Civic Design Review Phase 2

Chinatown Plaza

Chinatown Plaza Comment responses

Chinatown Plaza south wall

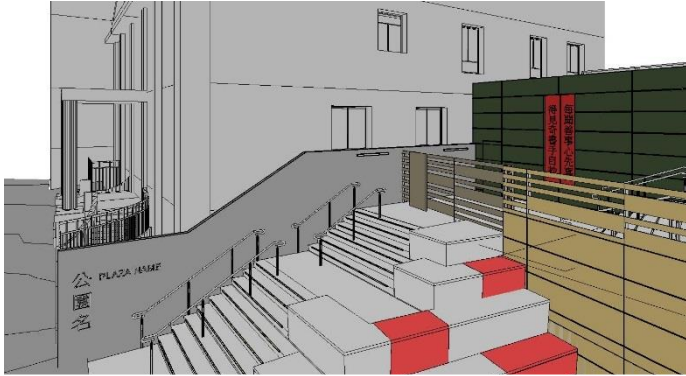
4. Explore alternative south wall designs
Multiple design options were studied; we worked with the Presbyterian Church to finalize – please see p.5
5. Shift couplets artwork north, away from blind door
Couplets were shifted north. Detail shown of how panels will be mounted and lighted. Please see p. 6-7

Chinatown Plaza fence material, couplets

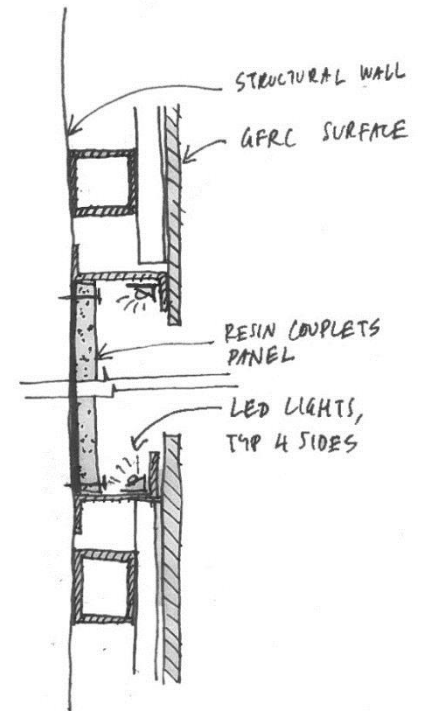
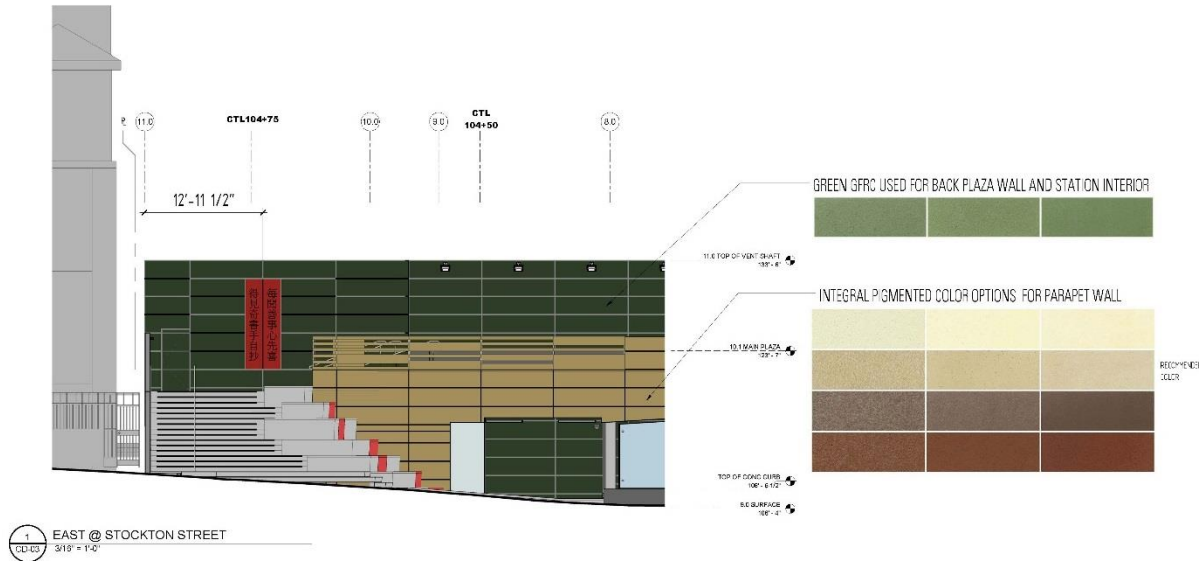
6. Ensure blind door is appropriately detailed
Please see concealed door detailing on p.8
7. Use integrally colored material rather than stained for mid plaza parapet/fence
We are currently working with SFAC and artist to select material from available integrally colored FibreC GFRC panels, please see p.7

Chinatown Plaza plaza trellis

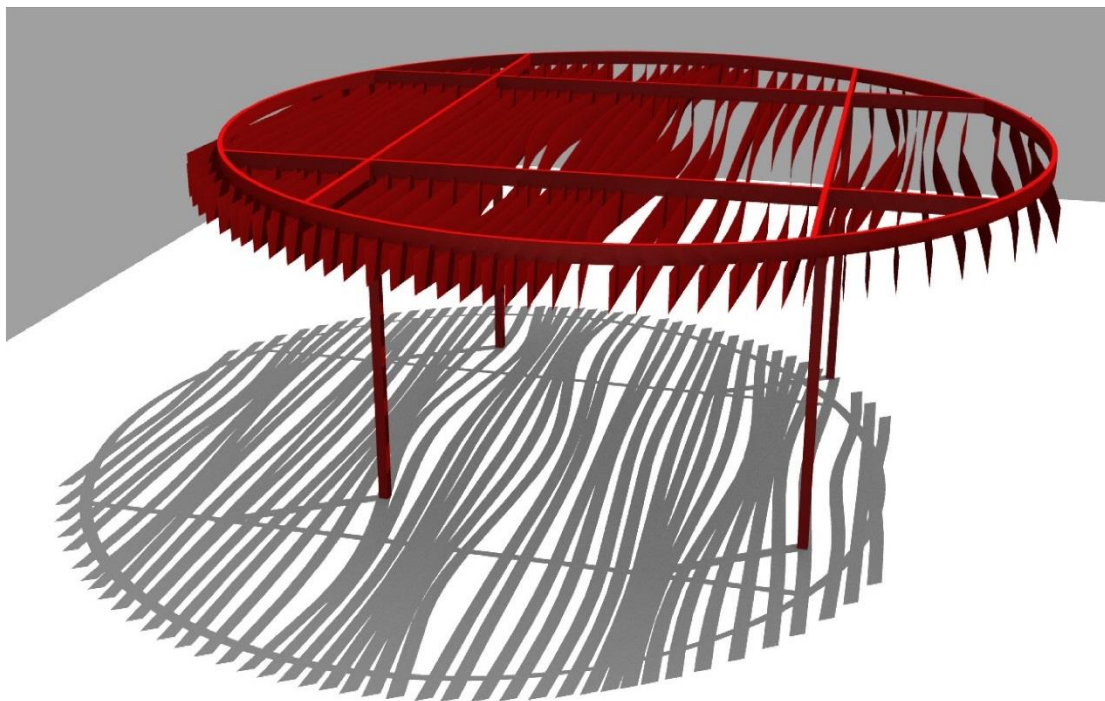
8. Use a matte or semigloss finish on the trellis
We propose gloss finish for maintenance and cost reasons. Matte finish is not available for exterior color applications.

CONCRETE STAR BENCH

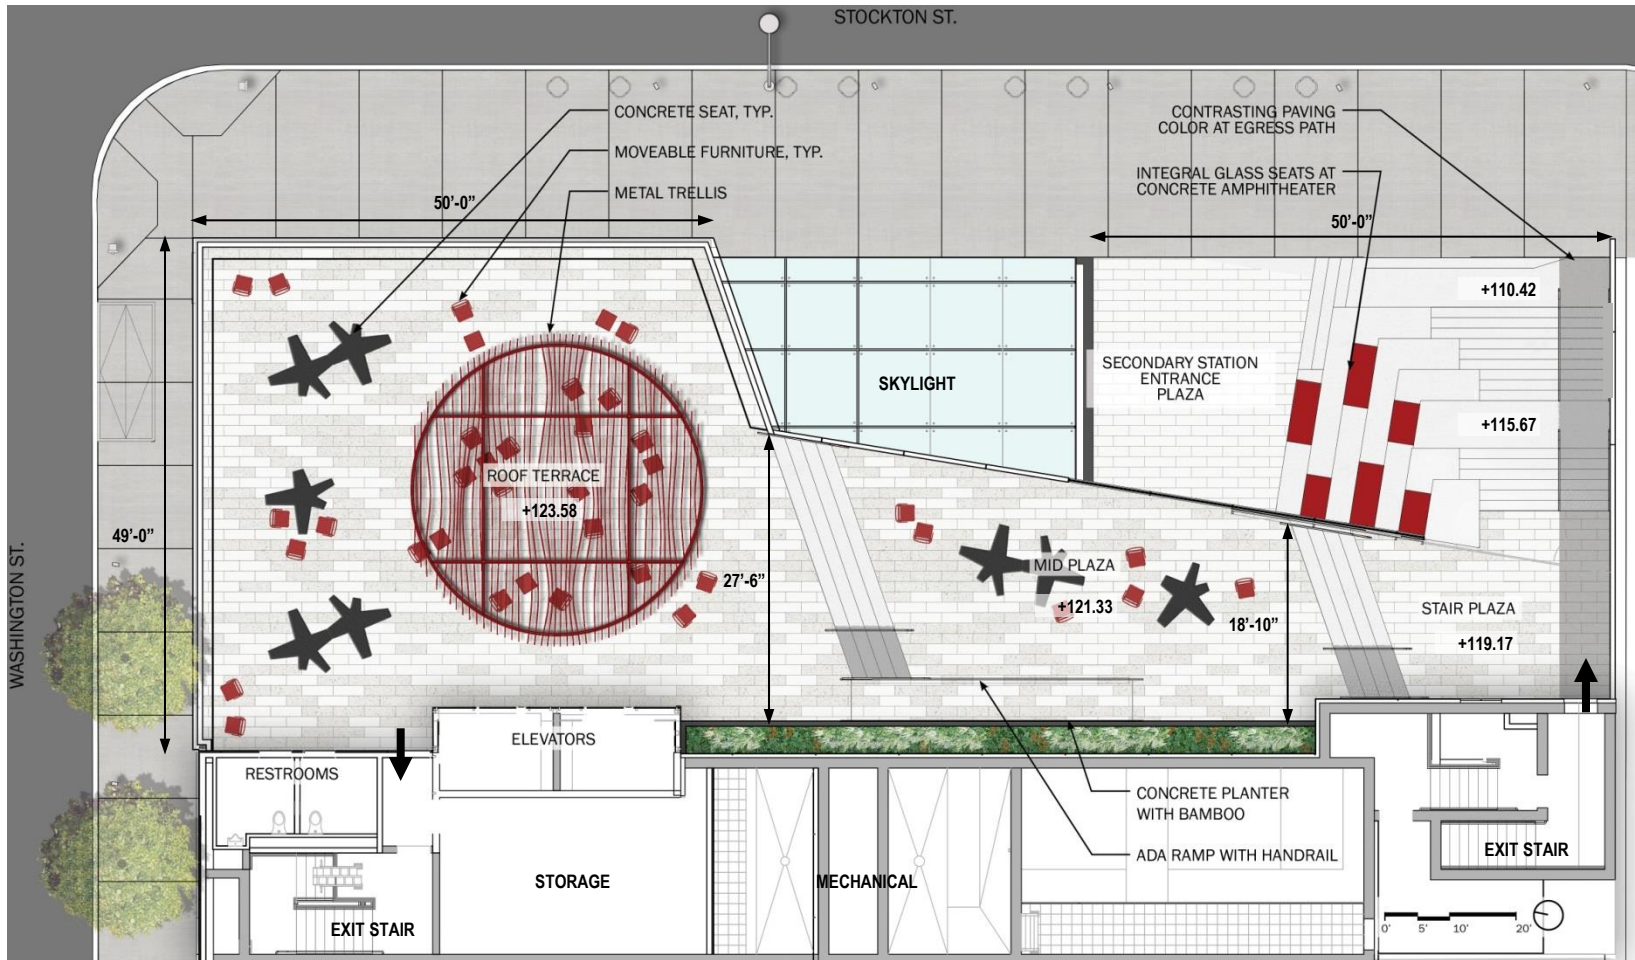
10. Resolve number and location of star-shaped benches to facilitate conversational groups
Three additional star benches were added to the plan. Please see plans on p.4 and images of p.6
